## Council Agenda Correspondence

**SUBJECT:** ITEM 7A – STUDY SESSION ON HIGUERA COMPLETE STREETS PROJECT

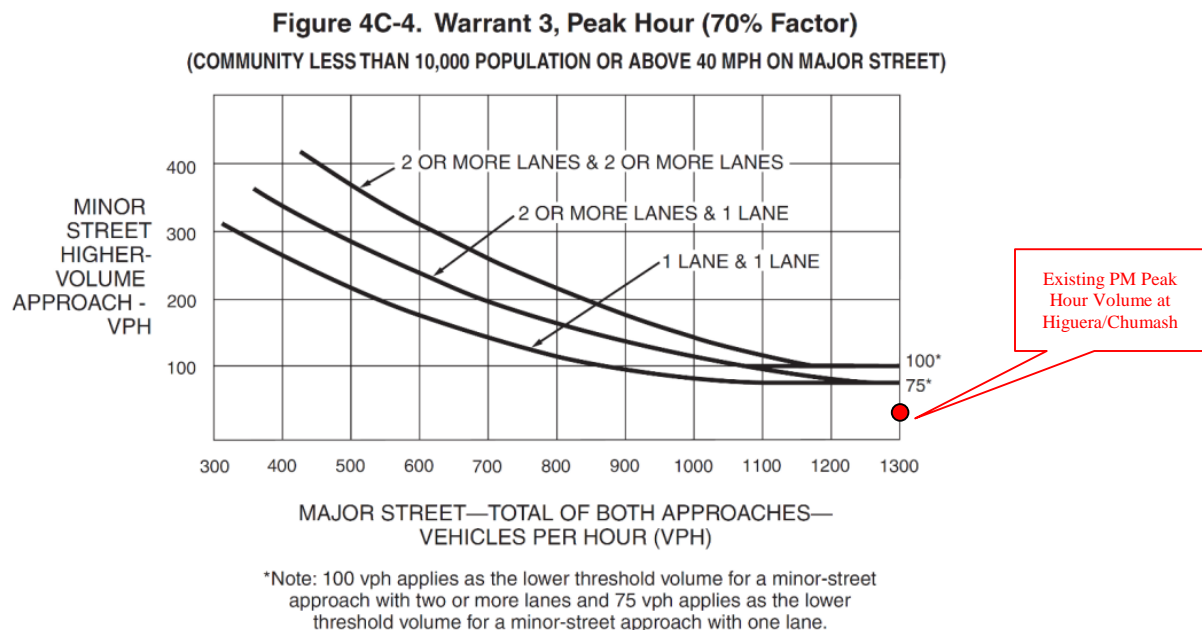
- 1) The report states that Chumash Dr. does not meet criteria for a traffic signal. How close is it to the criteria? Is the issue traffic volume, collision history, or other factors? Can average age of the resident in the neighborhood be considered? My understanding is that traffic engineers can waive MUTCD warrants when other factors are present?**

*Current conditions at this intersection were not particularly close to meeting required warrants for installation of a traffic signal pursuant to the California Manual on Uniform Traffic Control Devices (CAMUTCD). For reference, to satisfy warrants for signalization based on volume, the Peak Hour Warrant on a 40 mph street would require side street volumes that exceed 100 vehicles per hour (if two lanes per direction are present on the major street) or 75 vehicles per hour (if one lane per direction is present on the major street). Current peak hour approach volumes on the minor street (Chumash Drive) are 26 vehicles/hour during the AM peak hour and 31 vehicles/hour on during the PM peak hour period. Current volumes on the major street (Higuera Street) meet the required thresholds for signalization, but side street volumes (Chumash Drive) would need to more than double to meet volume-based warrants for signalization. The chart below shows existing volumes at Higuera/Chumash compared to Peak Hour warrant thresholds.*

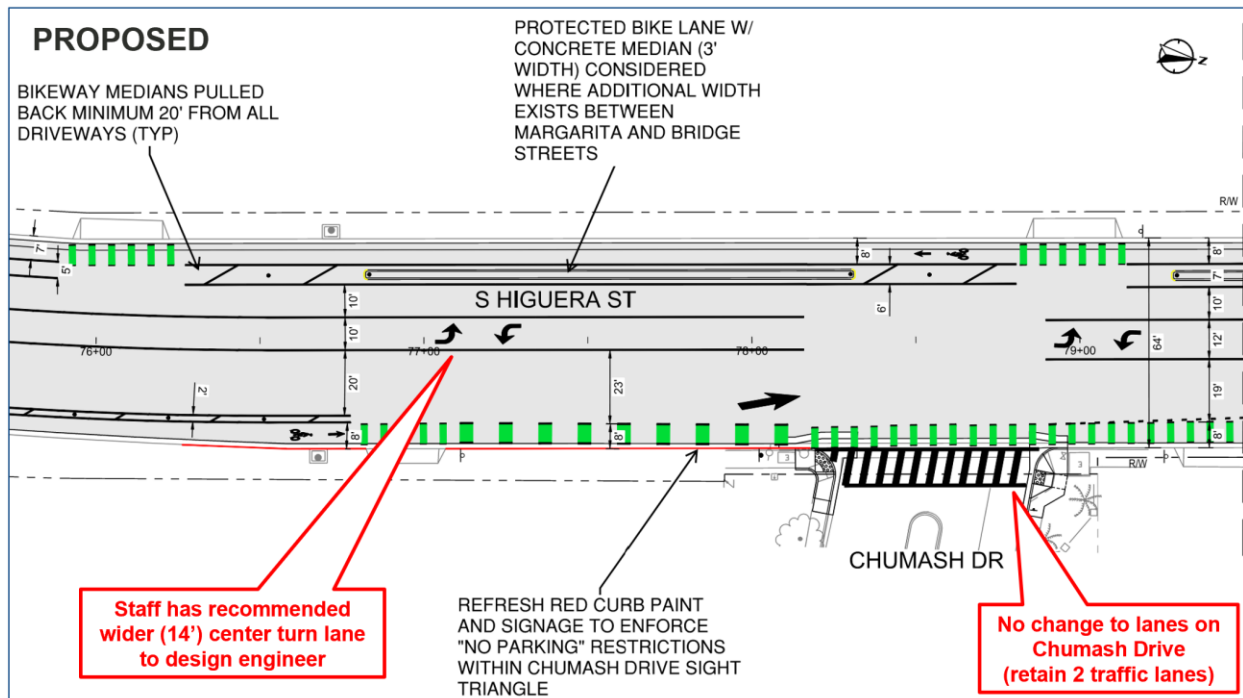
**4) What is the change in width to the center turn lane at Chumash Dr.?**

*The current width of the center turn lane at Chumash Drive is approximately 11 feet. While the current draft striping plans included in the Council Agenda Report show a 10-foot wide center turn lane as part of the project, staff intends to increase this width to at least 12 feet and has already provided this direction to the project design engineering consultant preparing the final plans. There may be flexibility to increase this turn lane width further, if desired by the Council.*

*The images below show existing and proposed configuration of the Higuera/Chumash intersection. Note that Higuera Street currently has one lane in the northbound direction at Chumash Drive, which would remain with the proposed project. The project would provide one lane in the southbound direction, which opens up to two lanes just south of Chumash Drive. The center turn lane and two lanes exiting Chumash Drive would remain with the project.*

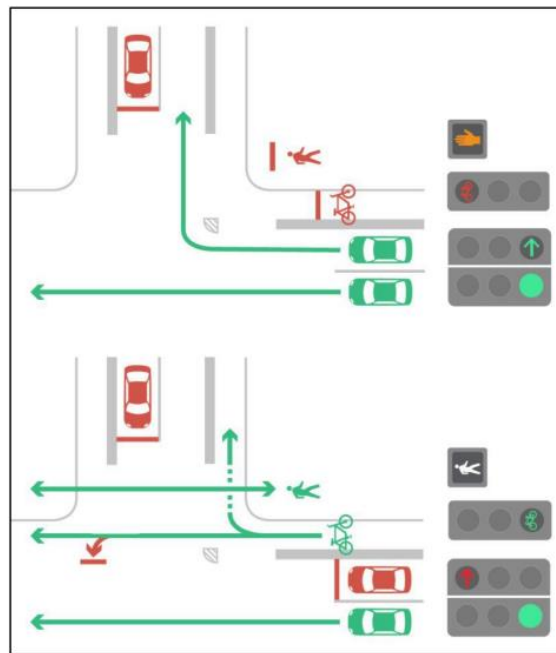
- 16) Regarding the intersection of S. Higuera and Suburban, in addition to the lighted signage being proposed for this intersection, have staff considered disallowing “right on red” at this intersection?**

*Yes, right-turns on red are already prohibited at this intersection (see image below).*
